Subject: WPPSS NUCLEAR PROJECT NO. 2
RESPONSES TO ROUND ONE QUESTIONS,
SET FIVE - PLANT SYSTEMS, PSB

Responses to Round One Questions
Set Five - Plant Systems, PSB

Round One, Set Six
Plant Systems Branch
005.1

Figure 10.2 -10

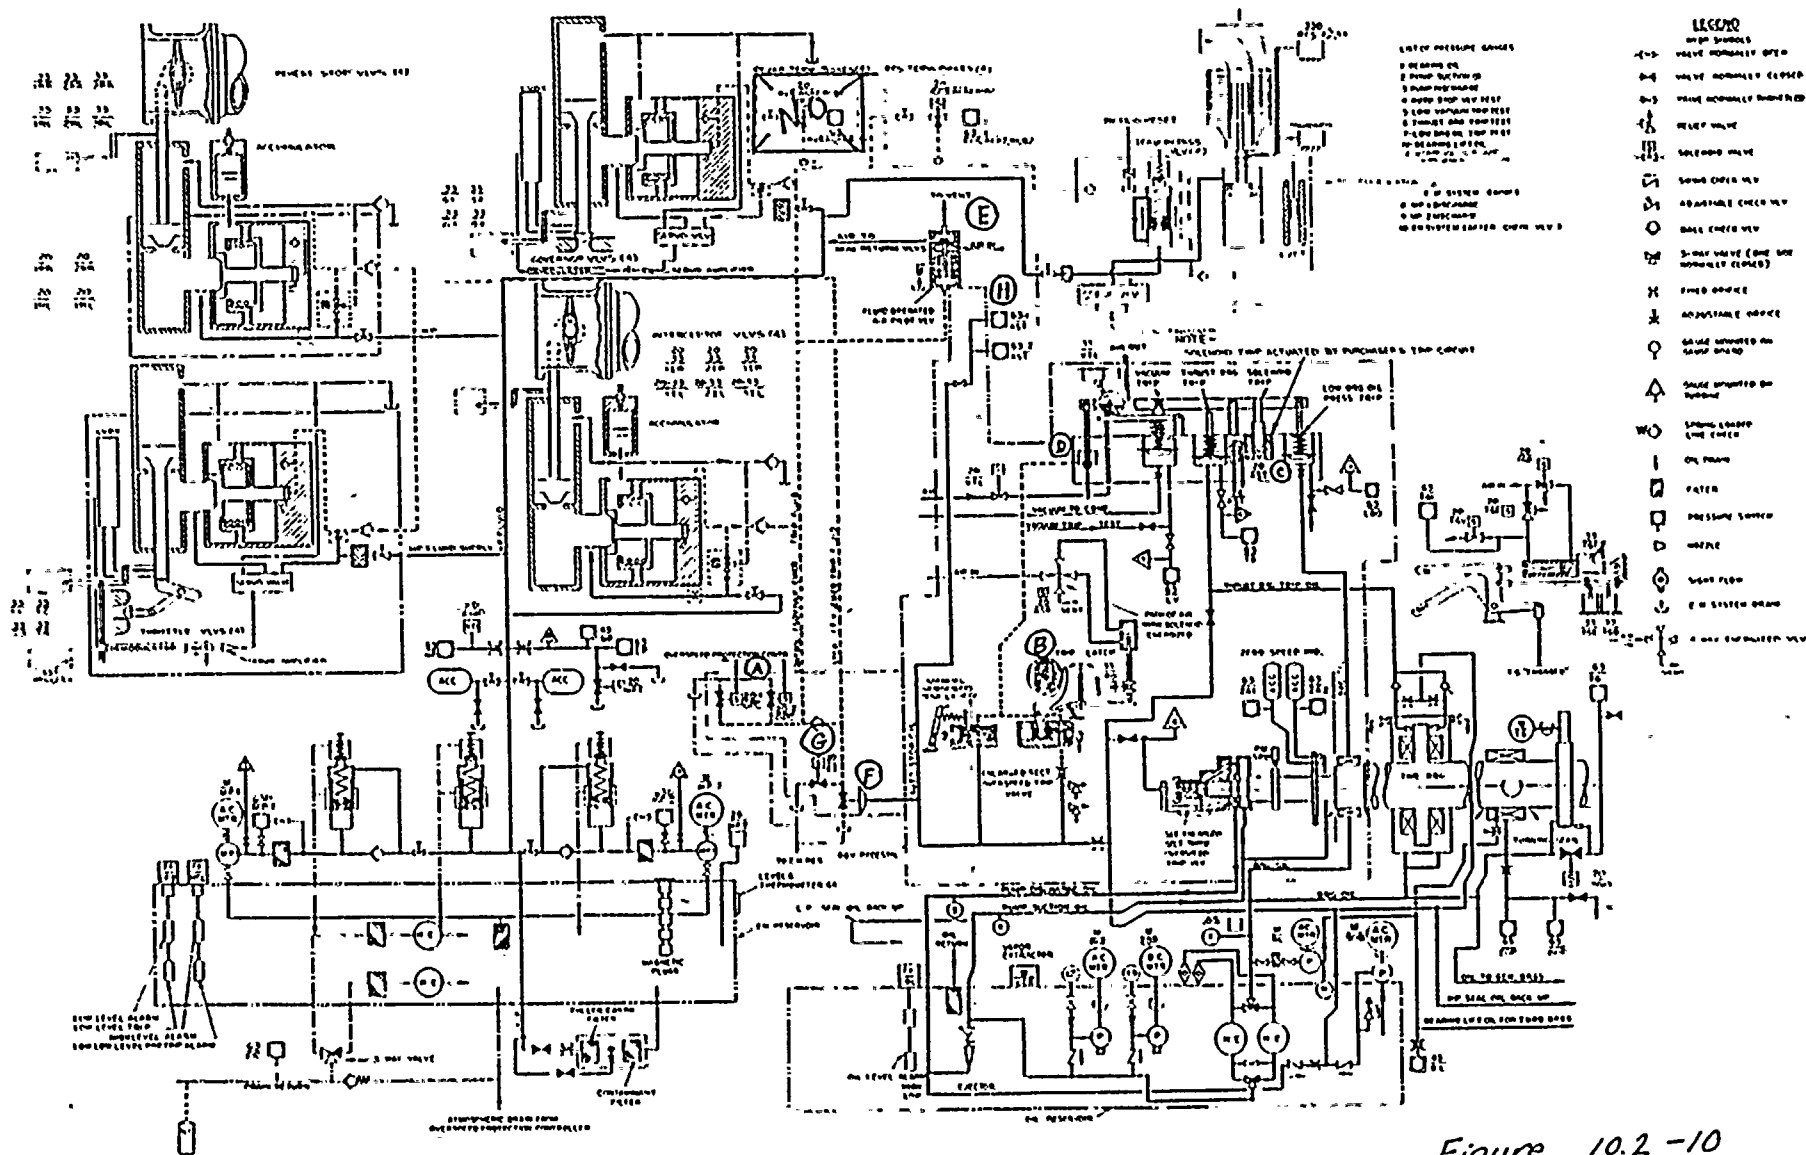
- 3) In order to evaluate the adequacy of the control and overspeed protection system provide schematics and include identifying numbers to valves and mechanisms (mechanical and electrical) on the schematics. Describe in detail, with references to the identifying numbers, the sequence of events in a turbine trip including response times, and show that the turbine stabilizes.

Answer: See new Figure 10.2-10 and revised pages 10.2-5, 10.2-6, and 10.2-7.*

Figure 14.2-5

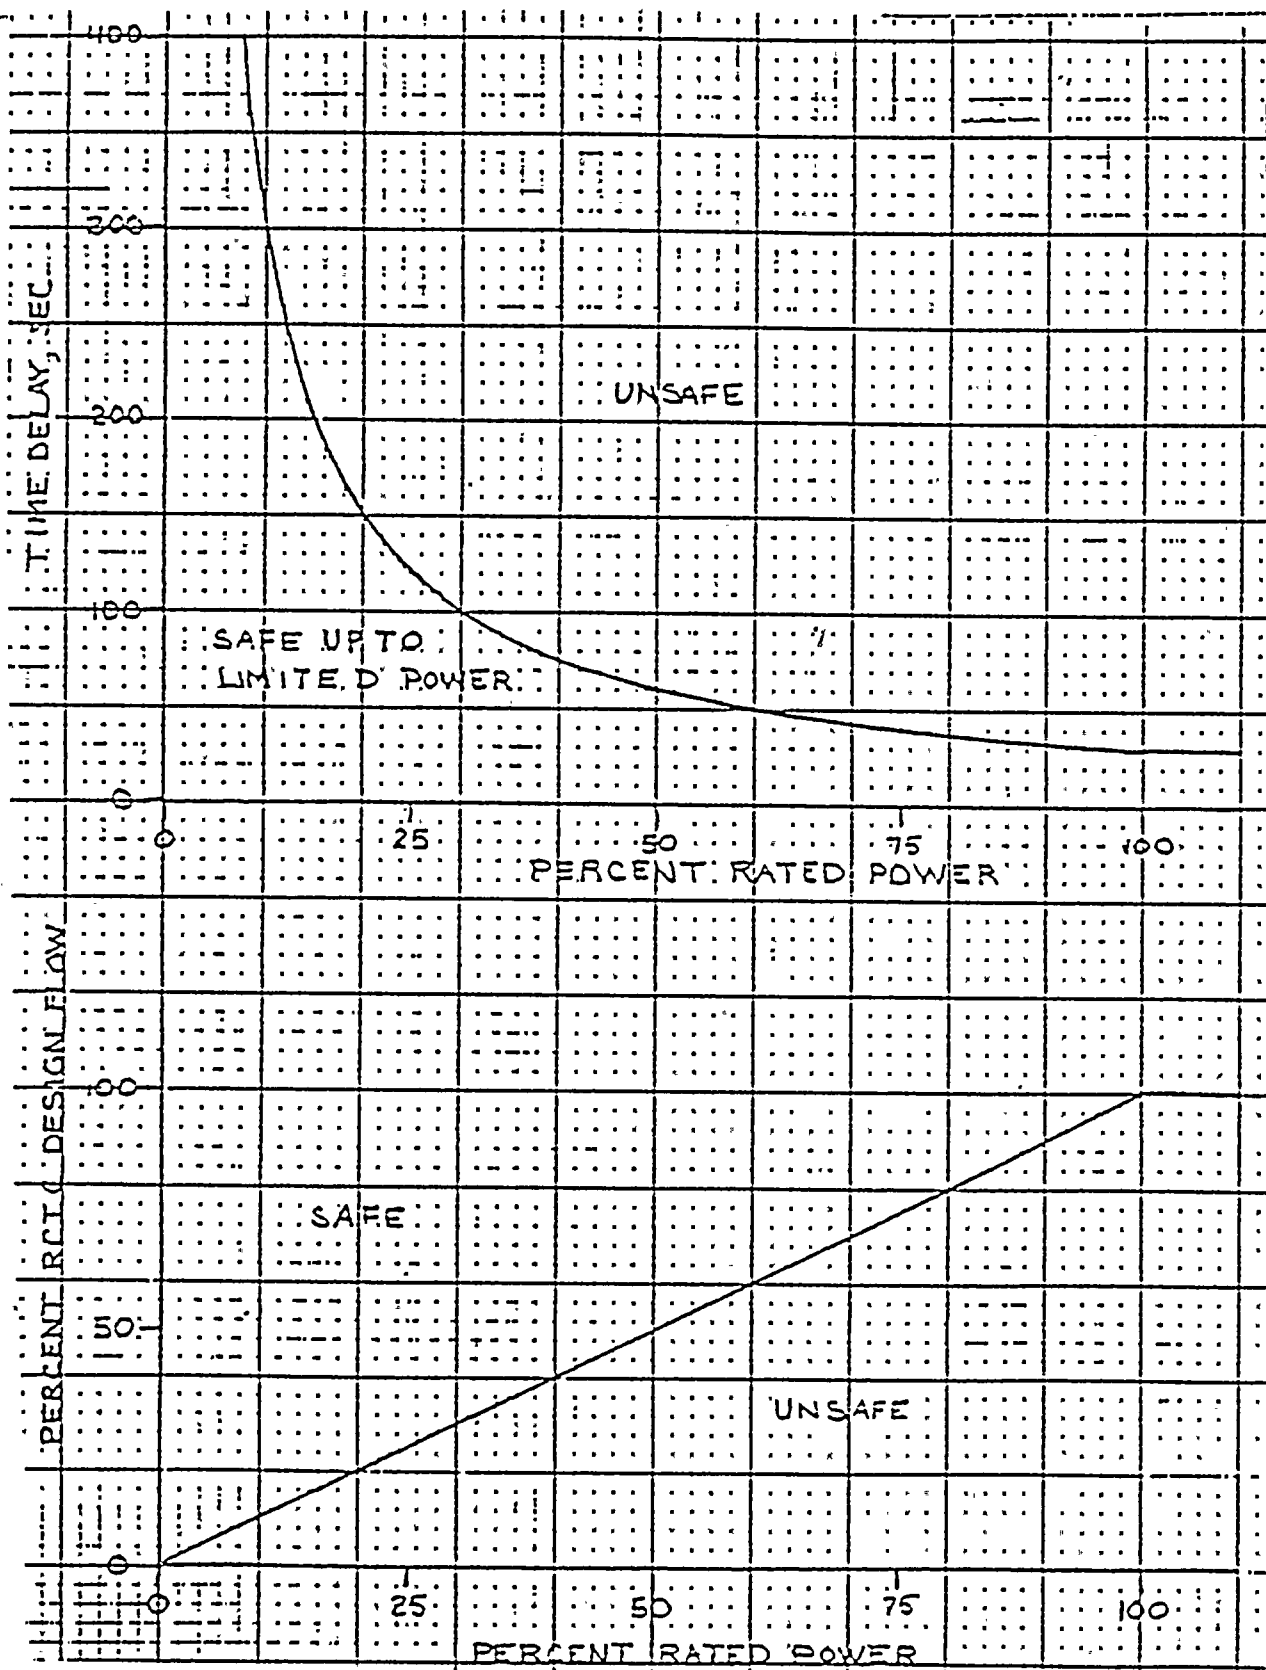
Modify the test abstract for the reactor core isolation cooling (RCIC) system to provide for five cold, quick starts of the system. Indicate the system conditions for a cold, quick start. The Level 1 acceptance criteria in your FSAR refer to operating restrictions presented in Figure 14.2-3 of the FSAR if these acceptance criteria are not met. However, this figure does not contain these restrictions. Provide the appropriate operating restrictions if Level 1 criteria are not met.

See the revised description for the RCIC startup test (Section 14.2.12.3.14). Also included is a new FSAR figure 14.2-5 "RCIC Acceptance Criteria Curves for Capacity and Activation Time."* The revised test description contains the five cold, quick starts referred to in the question. They are summarized below for clarity.
